As a resident of the Timbercrest neighborhood, I have several concerns with the proposed Fox & Fogerty on Yosemite Drive proposed subdivision (Concept Plan 9-SC-24-C), that I hope the planning commission will address.

Slope analysis from Subdivision Report #9-SC-24-C with the site plans overlaid.

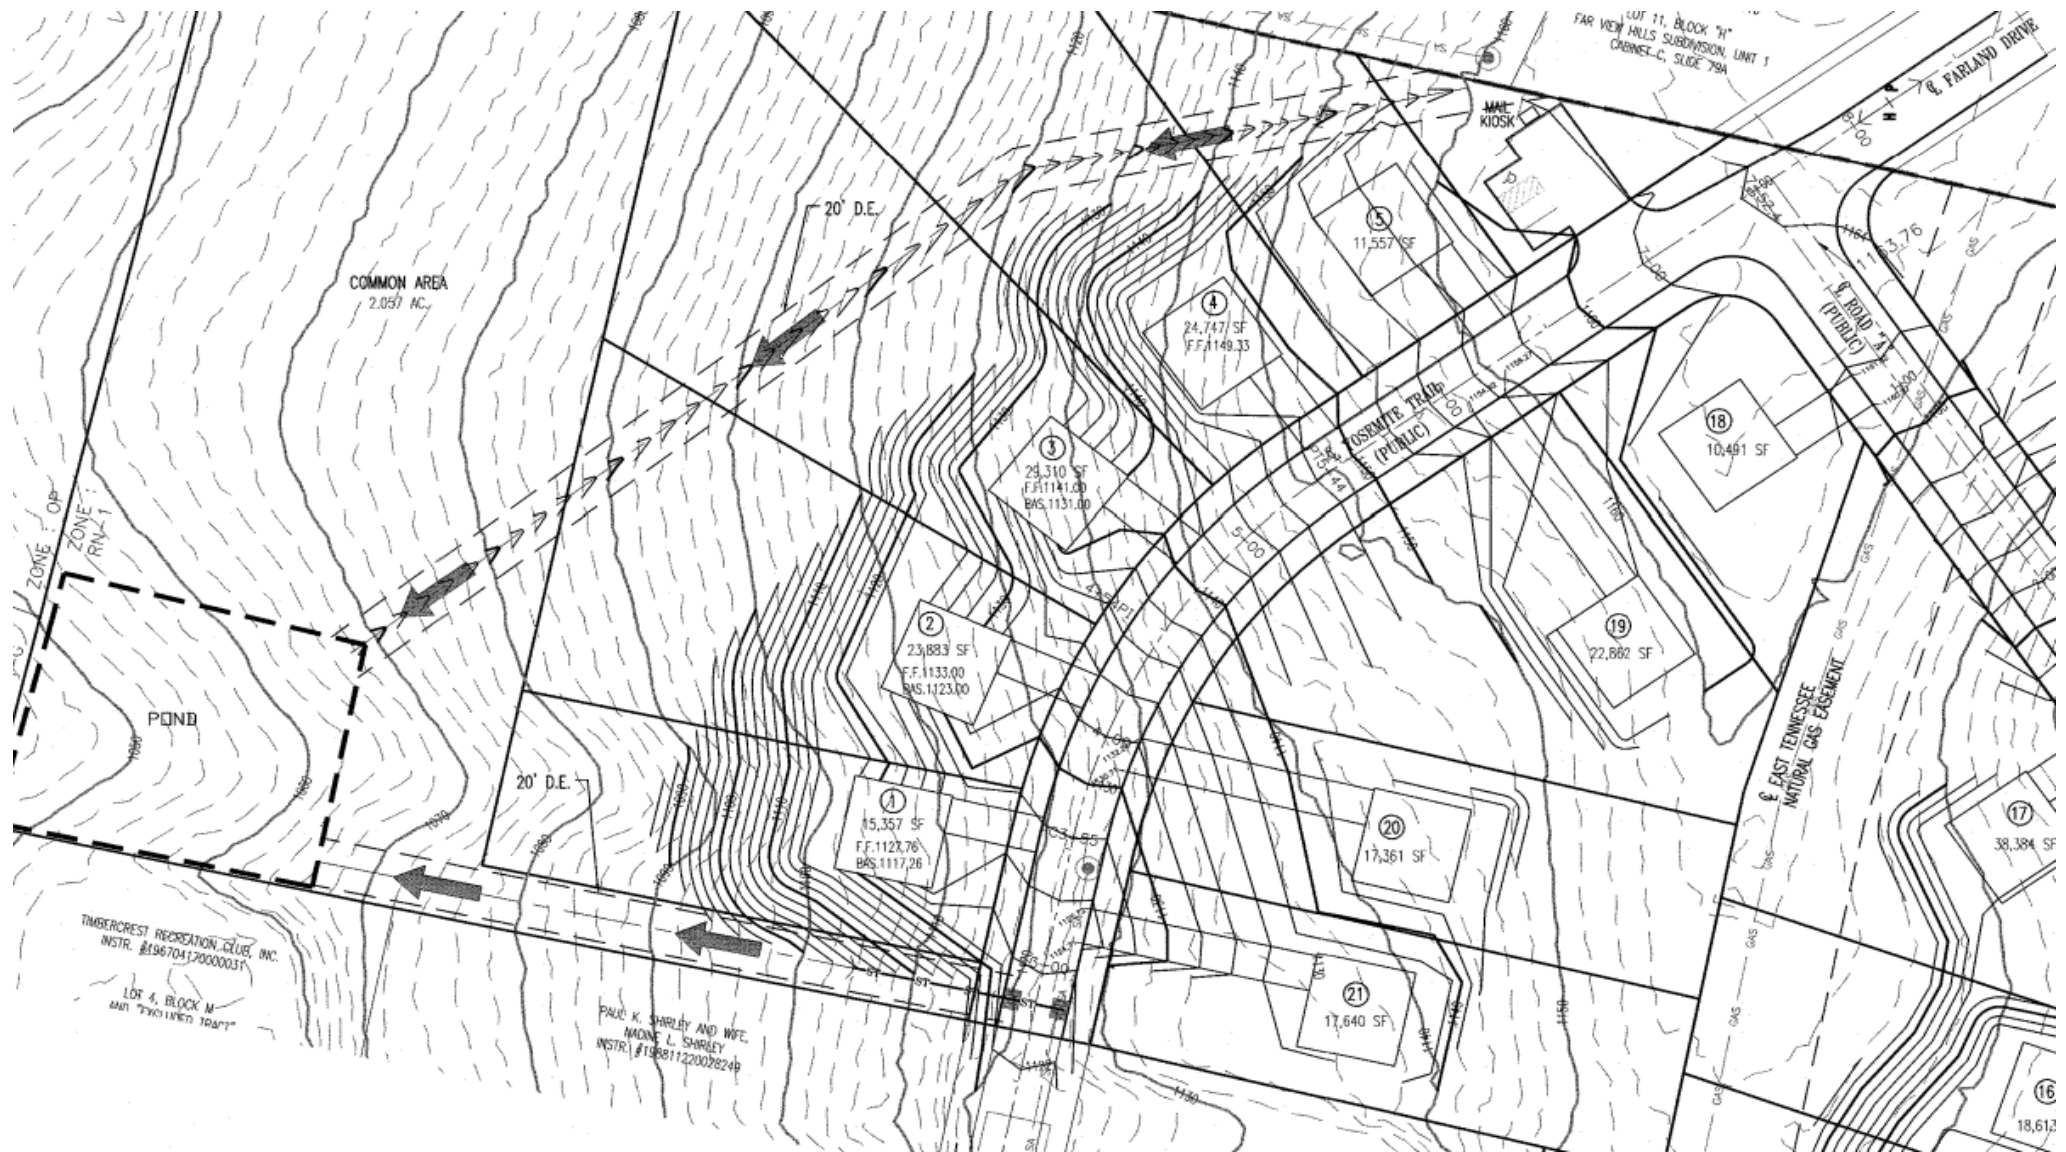
- Proposed lots 1, 3, & 4 are in an area with slopes greater than 25% and the site plans depict disturbance to more than 20% of these lots which appears to exceed the disturbance limitations of the Hillside Protection Overlay Zoning District.

Substantial portions of lots 1, 3, and 4 have slopes greater than 25%.

Knoxville Zoning Code Article 8.9 states the maximum density for slopes greater than 25% is 0.5 dwelling units per acre. The proposed plan has these 3 lots on less than 1.25 acres of land.
